SUBMITTER No.	364	ISSUE REFERENCE:	12027 / 17157
SUBMITTER TYPE		TOR CATEGORY	Project Description
NAME	DEEDI (Mining and Petroleum Operations)	RELEVANT EIS SECTION	Volume 3 – 1.1.2.4

SUBMITTER No.	364	ISSUE REFERENCE:	13018
SUBMITTER TYPE	Government	TOR CATEGORY	Project Description
NAME	DEEDI (APSDA Branch)	RELEVANT EIS SECTION	Volume 4, Chapter 2, p17: 2.2.2.6 Land Use, Existing Environment

SUBMITTER No.	419	ISSUE REFERENCE:	6017 / 4049 / 4113 / 6051 / 6052 / 17016 / 19008
SUBMITTER TYPE	Government	TOR CATEGORY	EMP / Project Description
NAME	DERM	RELEVANT EIS SECTION	All sections

Figure 1. Mine Infrastructure Plan

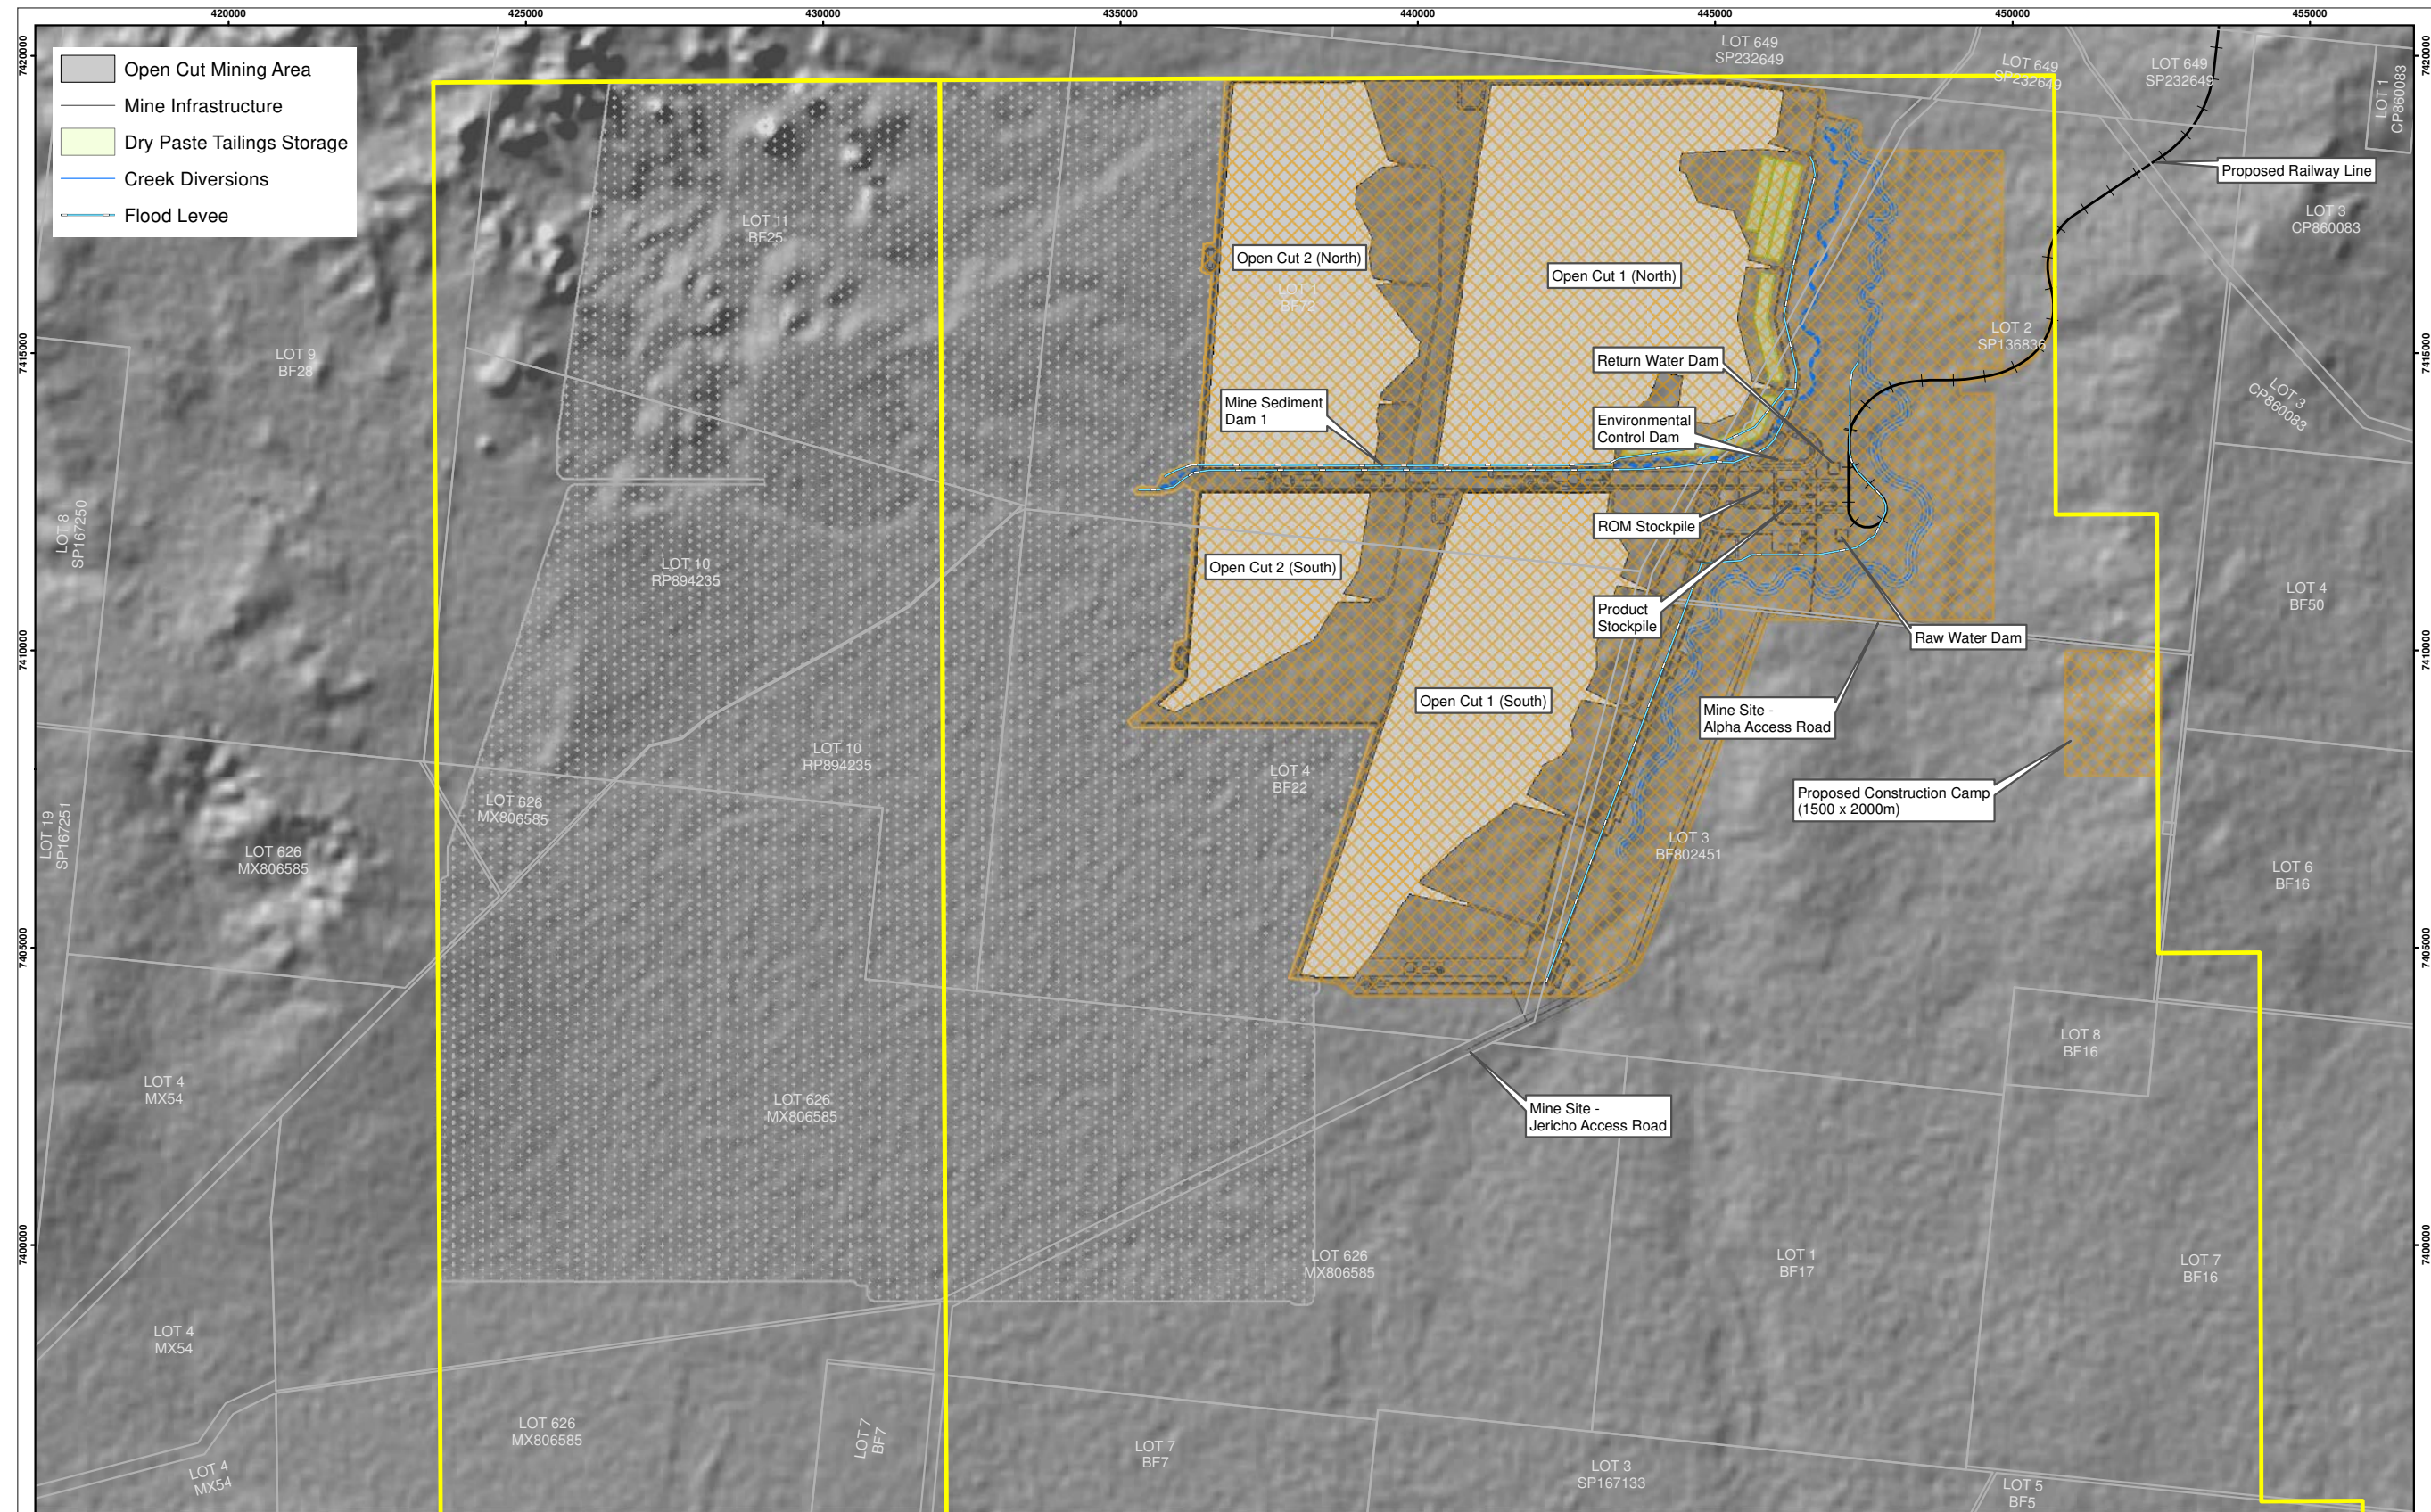
The EIS does not provide the necessary details on the proposed containment system proposals for the mine site. The EIS and EM plan should describe and identify on maps at suitable scale the location and form of all necessary mining infrastructure on the mine site.

The EIS and EM plan should detail, as a minimum:

1. The location and size of open-cut pits, including proposed size and shape of final voids
2. The location and footprint of essential plant, including the coal preparation plant, stockpiles and loading facilities
3. The location and size of overburden dumps
4. A containment system for the management and permanent storage of tailings
5. A containment system for the management of runoff and seepage from overburden rock dumps
6. A site water management system for the management of runoff from around the site and the surrounding catchments that would normally pass through the site
7. Any associated diversion channels, levees and dams required to control and store contaminants generated by the mining activities or to protect the mine workings from flooding

The EIS and EM plan should as a minimum:

1. Undertake a preliminary design for the purpose of sizing and locating infrastructure, overburden dumps, tailings dams and associated diversions and flood levees
2. Include a site water management system for the management of runoff from around the site and the surrounding catchments
3. Identify and assess the potential environmental impacts of proposed developments.

A revised mine site infrastructure layout has been prepared to detail these features (see Figure 1).

1. Figure 1 shows the location, relative size and shape of the final voids. The total area of footprint for the open-cut mines is 7437 ha. The individual size for each open-cut mine is:
 - Open-cut No. 1 North: 2803.03ha
 - Open-cut No. 1 South: 2077.41ha
 - Open-cut No. 2 North: 1776.20ha
 - Open-cut No. 2 South: 780.22 ha

2. The location and footprint of essential plant is shown on Figure 1. The footprint area for the CHPP, stockpiles and loading facilities is 120ha.

3. The location and size of the overburden encapsulation areas is shown on Figure 1. The collective size of these areas is 1816ha.
4. Proposed containment systems for the management and permanent storage of tailings and rejects are detailed in the *Tailings Storage Facility Update* report (contained in *Appendices – Volume 2* of this SEIS). The tailings will be dewatered using filter press conveyors and the tailings paste and rejects will be trucked to disposal cells constructed initially within the box-cut spoil piles and later within the in-pit spoil piles.

Figure 3. Lot 4 SB687 – Remnant Vegetation

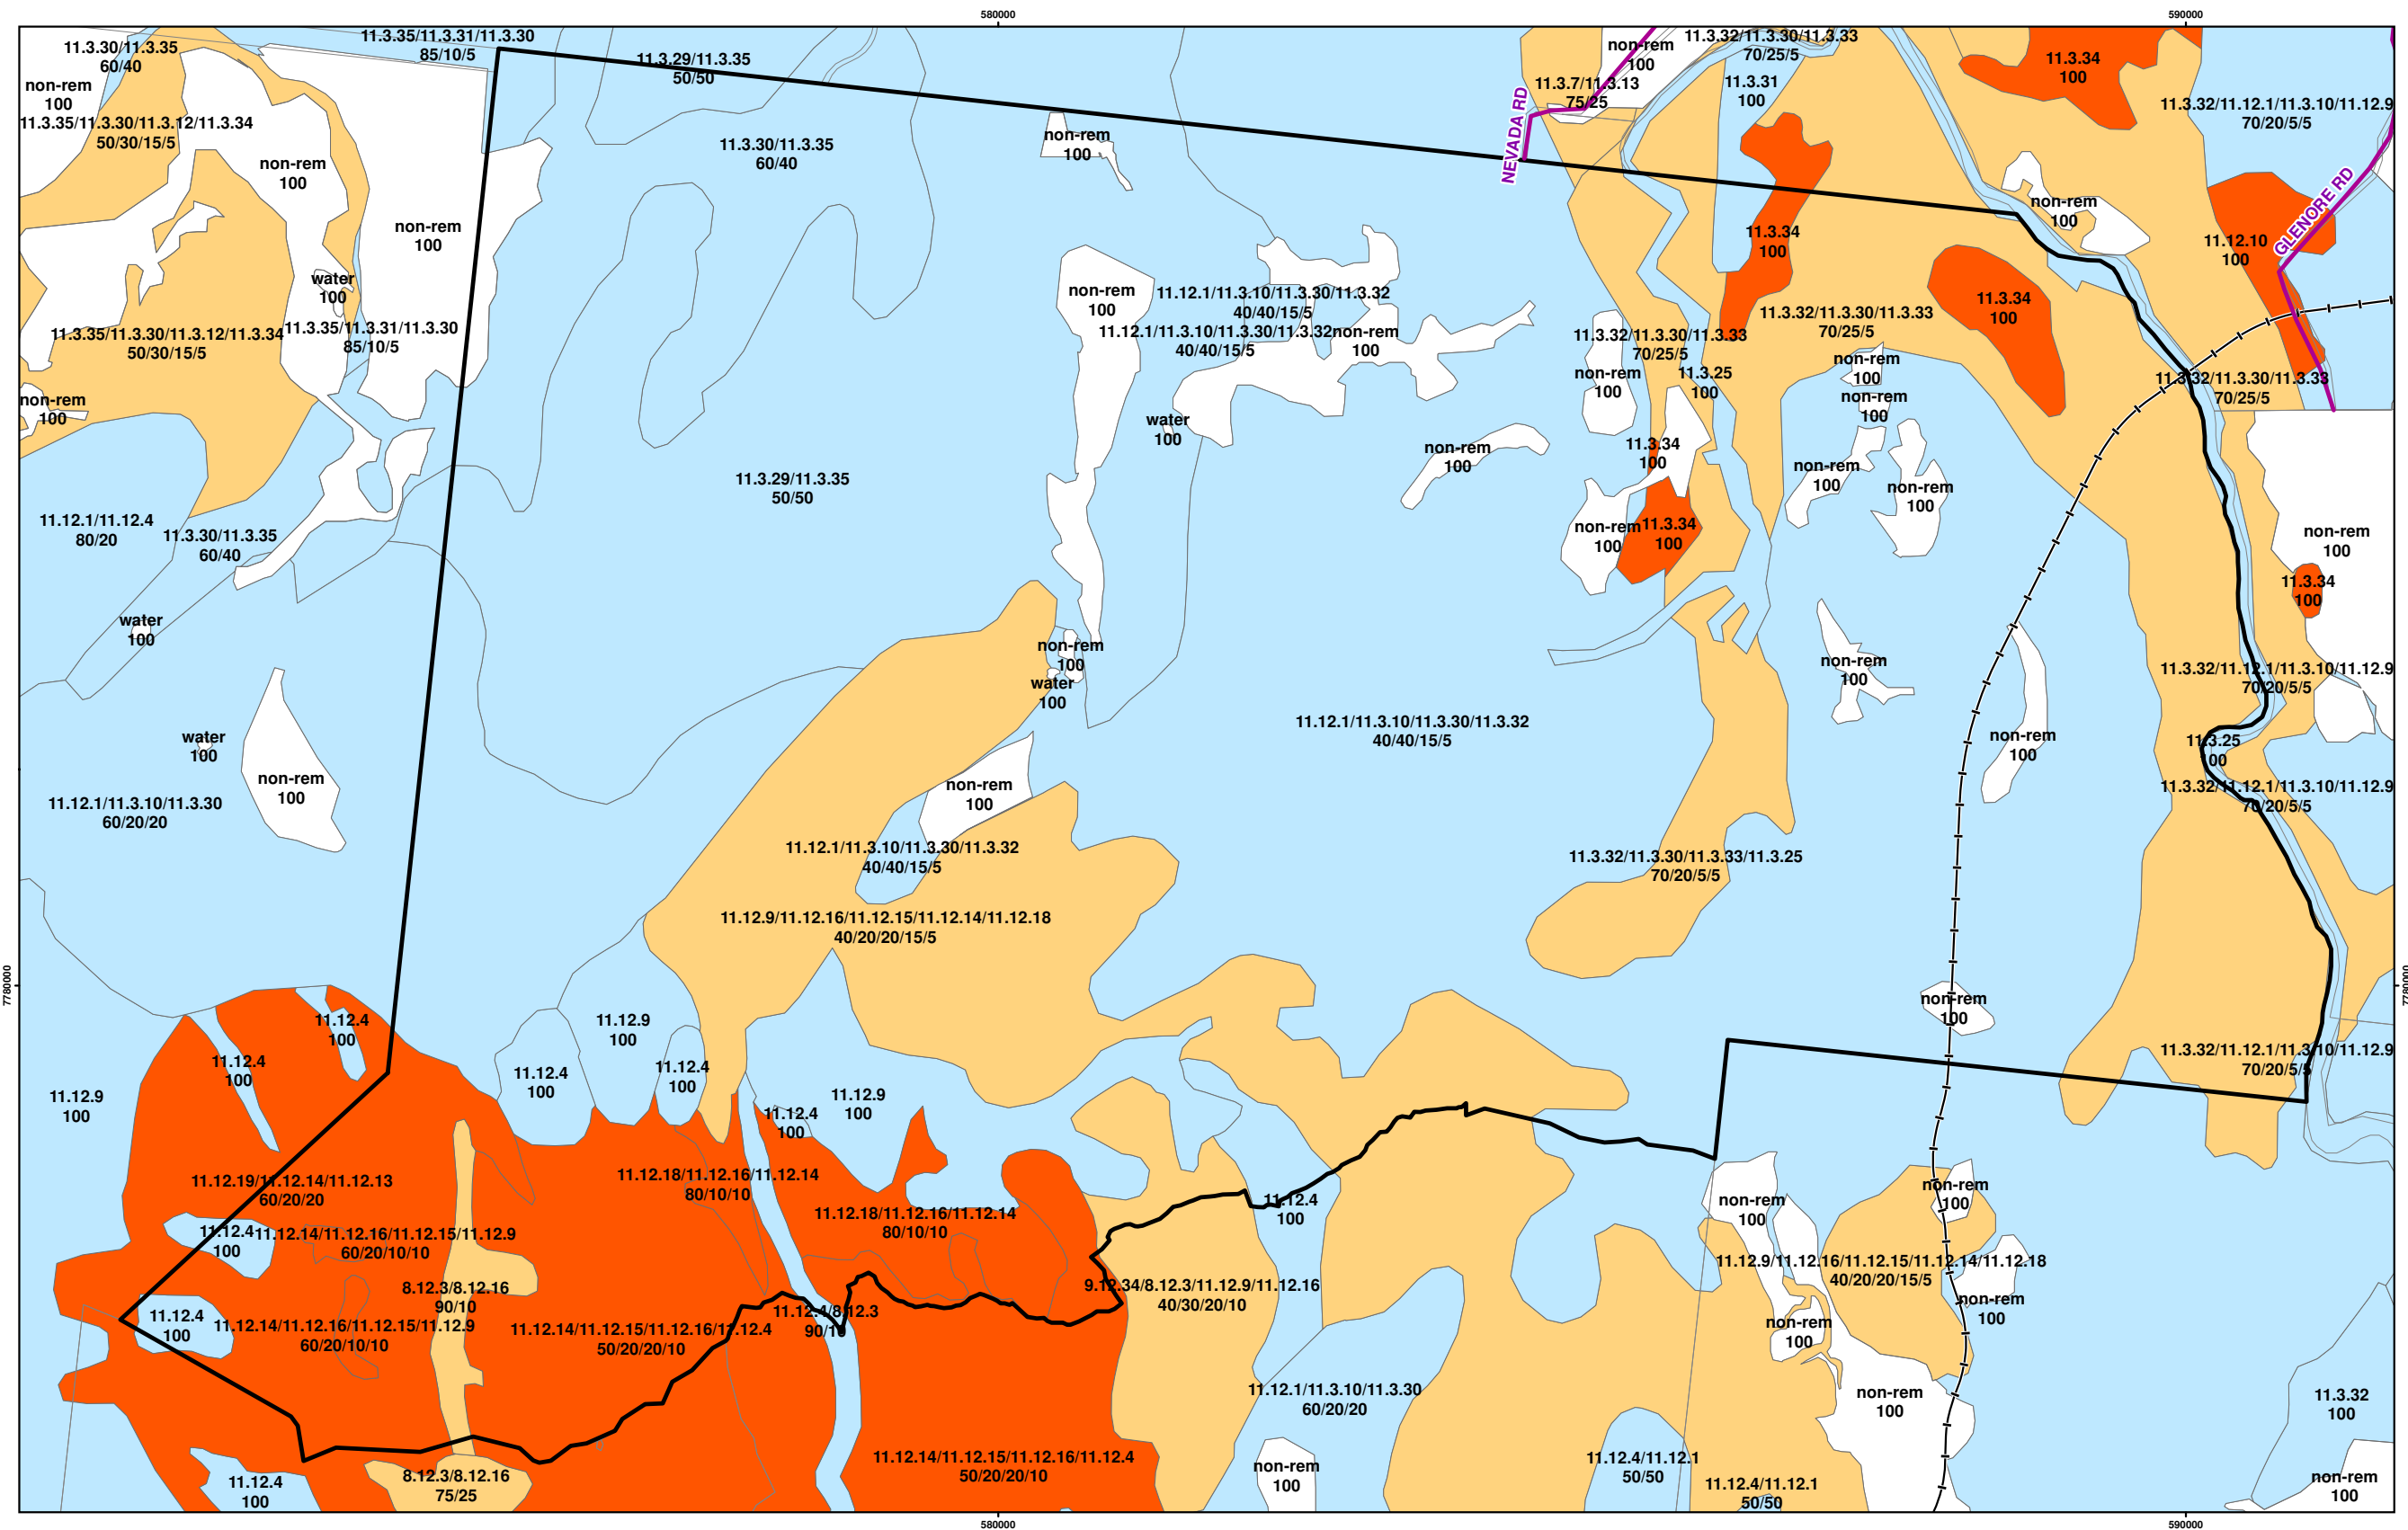
Reference is made to rail maintenance and provisioning facility being constructed on a site adjacent to the railway for refuelling and servicing, servicing rolling stock etc without any detail in relation to the maintenance yards, crossing of rail lines, freight etc or location of the facility.

The proposed alternative location for the marshaling yard is situated alongside the proposed rail corridor in Lot 4 on SB687 (see Figure 3). This area contains the following least concern remnant regional ecosystems:
